SERVICE BULLETIN
SV118
5/19/2015

REGARDING: Ground Location on 2015+ Ford F150

QVM Bulletin: Q-231

F-150 Aftermarket Direct to Battery Connections

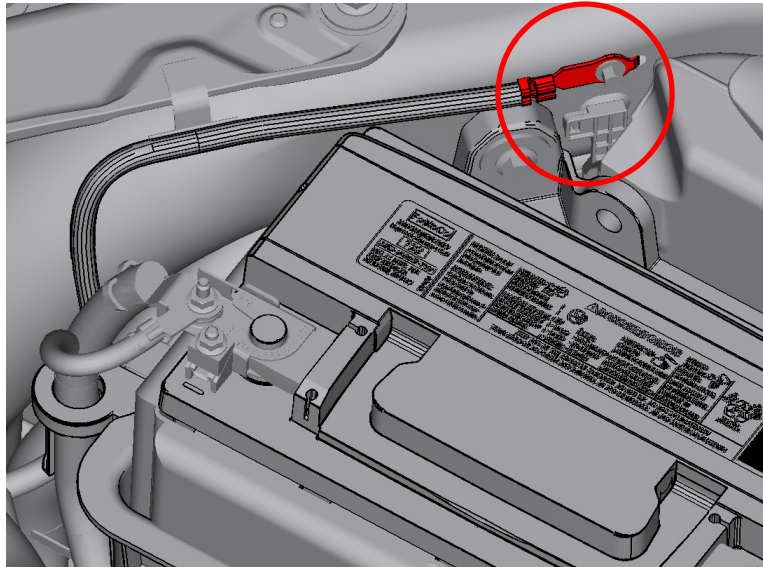
Description: The 2015MY F-150 battery charge state is determined with a Hall Effect sensor on the negative battery lead. All negative current must pass through this sensor. Failure to do so will result in malfunction of the vehicle charging system and shortened battery life. **Do not make direct to battery connections at the negative battery post.**

Procedure: To ensure proper charging system function, the battery return should be made at the grounding point shown and circled in red in the picture below:

Addition grounding point specifications:

Eyelet ID: 7mm
Bolt: M6
Torque: 9 +/- 1.4 Nm
